**Re: Responses to Technical Review Comments
Dewey-Burdock Project Large Scale Mine Permit Application**

On behalf of Powertech (USA) Inc., this letter is provided in response to the technical review comments issued December 14, 2012 and March 1, 2013 for the above-referenced large scale mine (LSM) permit application. For convenience, the comments are provided below in italics followed by the responses. Application replacement pages are enclosed along with an index of changes (three hard copies and one electronic copy on CD). The replacement pages are included as individual PDF files that correspond to the changes shown on the index of changes. For convenience, the enclosed CD also includes a folder with replacement pages incorporated into the application text and appendix files. Only files that were updated as a result of the comment responses are included. In addition, Attachment A provides pre-operational and end-of-production water quality from operating ISR facilities as requested in comment #5.

Technical Comments from December 14, 2012 DENR Comment Letter

Figure 1. Baseline Soil Salinity Profiles - Burdock Land Application Area

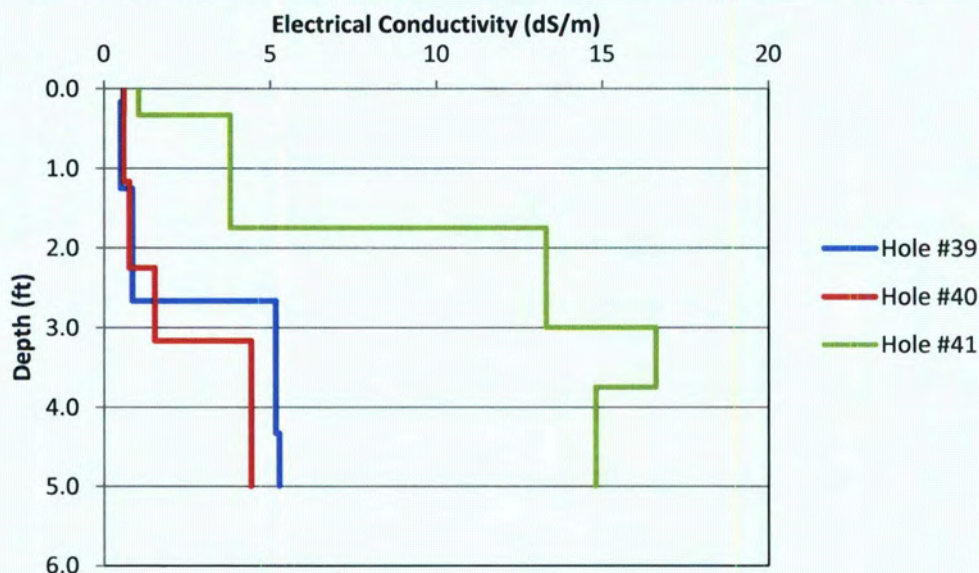
Please discuss the potential for the buildup of salts in the soil profile and the development of saline seep conditions in the land application area. Also, please describe the measures Powertech plans to take to mitigate any problems that develop from salt buildup and saline seep.

Baseline soil salinity profiles for soil samples collected from within or near the Burdock and Dewey land application areas are presented in Figures 1 and 2. These were generated using the laboratory-measured saturation extract electrical conductivity (EC) presented in Appendix 3.3-A. The salinity profiles represent typical soil salinity conditions in this semiarid area, with baseline soil salinity increasing with depth. These figures show that the top 1 to 3 feet, where most of the plant root zone is located, has salinity ranging from about 0.5 dS/m to greater than 5 dS/m. The salinity from 3 to 5 feet below ground surface is considerably higher, ranging from about 5 to 15 dS/m. According to the *Western Fertilizer Handbook* (California Plant Health Association, 2002), soils that have a conductivity of the saturation extract greater than 4 dS/m and exchangeable sodium percentage (ESP) less than 15 are considered saline soils. Figures 1 and 2 show that generally the near-surface soils do not meet this classification, although there are some instances where the baseline salinity in the top 3 feet exceeds 4 dS/m. Note that the highest levels of baseline soil salinity are associated with samples collected in or near drainage bottoms (#41 and #73) and may not be as representative as the other samples of typical land application baseline soil salinity (refer to Plate 3.6-1 for soil sample locations).

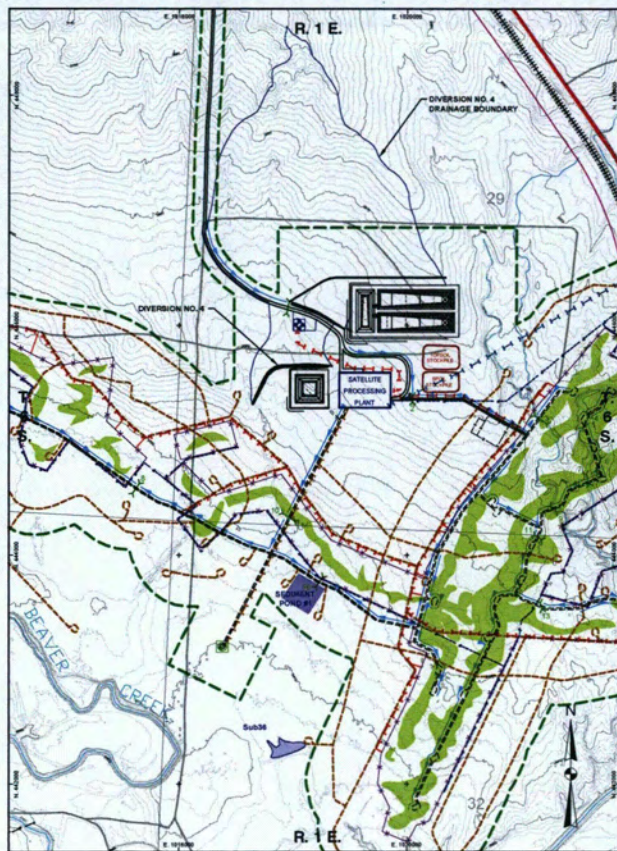
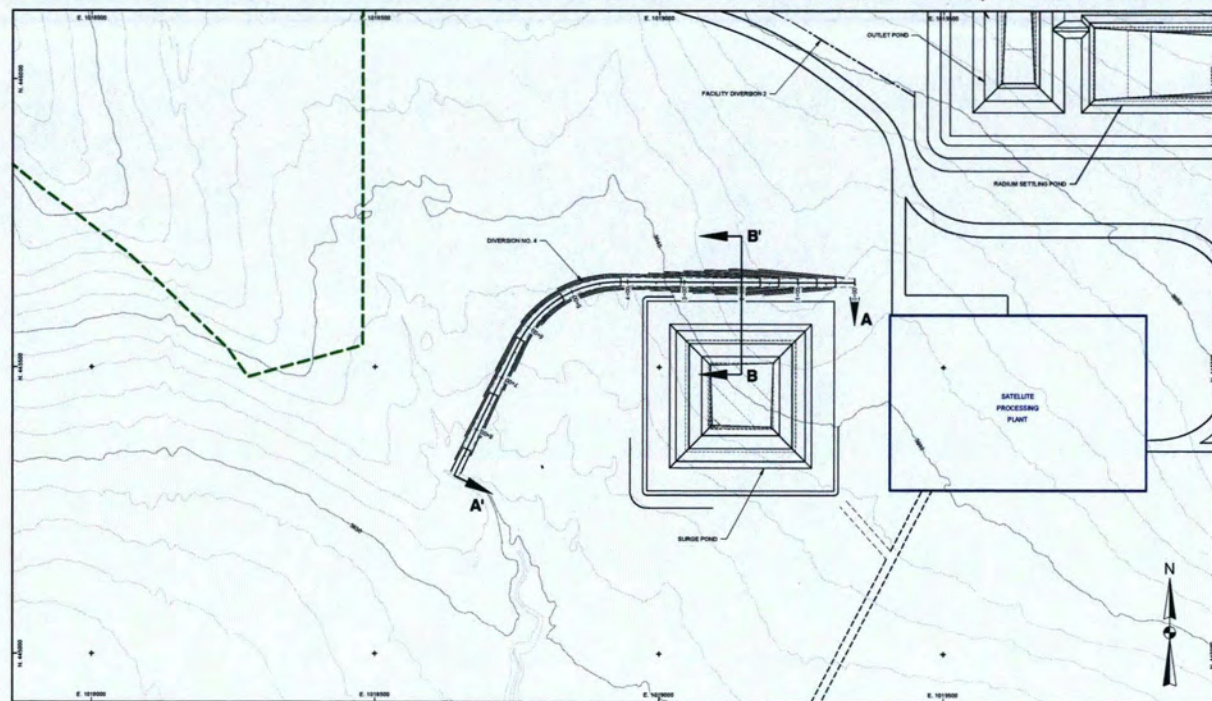
2. ARSD 74:29:07:09(6): *Will storm water diversions around the ponds in the land application option be necessary to keep storm water out of the ponds during storm events?*

Response: Two new storm water diversions (Diversion Nos. 4 and 5) have been designed for the Dewey area in the land application option (Plates 5.3-17b and 5.3-18). These diversions are designed to keep storm water out of the treated water storage ponds and spare storage pond. In addition, a new diversion has been designed to keep storm water out of the surge pond in the Dewey area in the deep disposal well option (Plate 5.3-17a). These diversions are capable of passing the 2-year, 6-hour storm event without erosion and have the capacity for a 100-year, 24-hour event. In addition, one new diversion (CPP Facility Diversion No. 4) has been designed for the central plant pond (Burdock area) in the land application option. This diversion has been designed for the 6-hour probable maximum precipitation (PMP) event in accordance with ARSD 74:29:07:09(6).

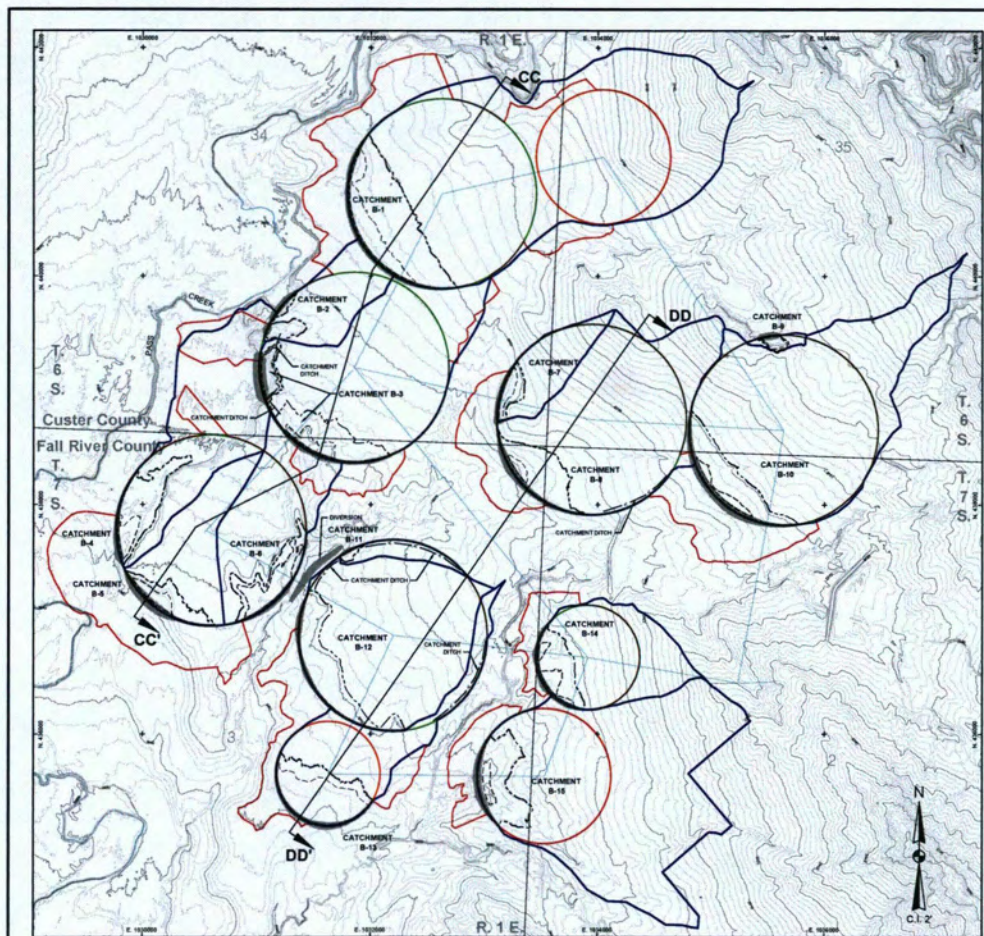
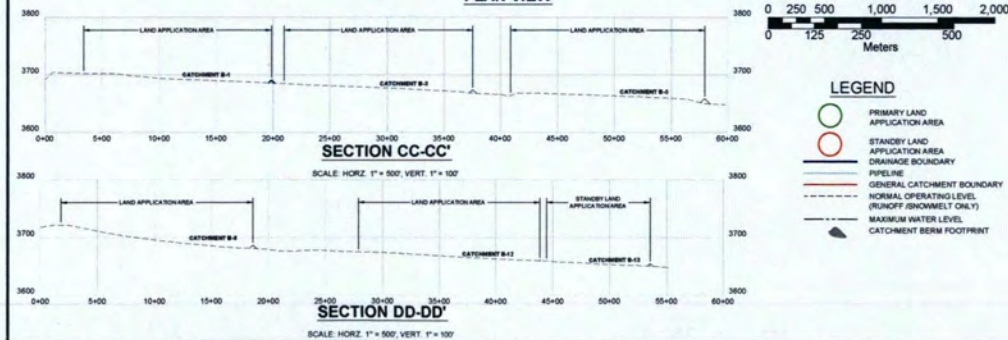
15. Plates 5.4-1 and 5.4-2: *On each plate, please show the wetted perimeter of the normal operating level behind each catchment berm. Also, please show the location of the excess water level markers and the pumps and piping for the excess water. Are there any plans to pump water from the normal operating level if increasing Se, As, SAR, or other trends are noted? Finally, please submit electronic versions of Plates 5.4-1 and 5.4-2 in dwg or ArcMap format.*

Response: Plates 5.4-1 and 5.4-2 have been revised to show the wetted perimeter of the normal operating level. These plates, which were formerly provided along with the requested copies of GDP permit application comment responses, are now being incorporated as LSM permit application plates using the same plate numbers. In addition, Section 5.4.1.1.2 has been revised to reference these plates and discuss catchment area operation. It is important to note that the land application systems will be operated in accordance with GDP permit conditions, which will not allow land applied water to accumulate in the catchment areas during dry conditions. Therefore, the “normal operating level” represents the maximum level allowed to fill with runoff and snowmelt while still maintaining adequate freeboard for the 100-year, 24-hour runoff event. The catchment areas will not be used to store land applied solutions and only will contain water following rainfall or snowmelt events. The normal operating level will be delineated with a clearly visible marker such as a t-post, which will be installed on the catchment berm or another highly visible location.

Please note that the conceptual catchment area design in the Dewey area has been revised. The former catchment area D-10 conflicted with the primary access road to the satellite facility. Therefore, the conceptual design for D-10 has been modified and a new catchment area (D-15) has been added. These changes are reflected on the revised Plate 5.4-1. Plates 5.4-1 and 5.4-2 will be provided electronically under separate cover in AutoCAD .dwg format as requested.
